No. 98-3

Incorrect Marking on II-V SSM Service Tool # 91-816922-3

- a** - 2.198 in. Diameter Tool
- b** - Should Read

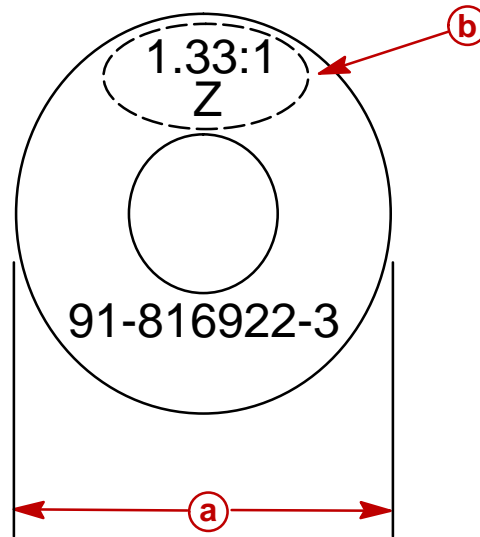
Shimming tool, part number 91-816922-3 which measures (2.198 in. Dia.) must have the stamped number of (1.33:1 and letter "Z").

If this tool is marked incorrectly, stamp the correct number and/or letter onto the tool and (xxxxx) out the incorrect number and/or letter.
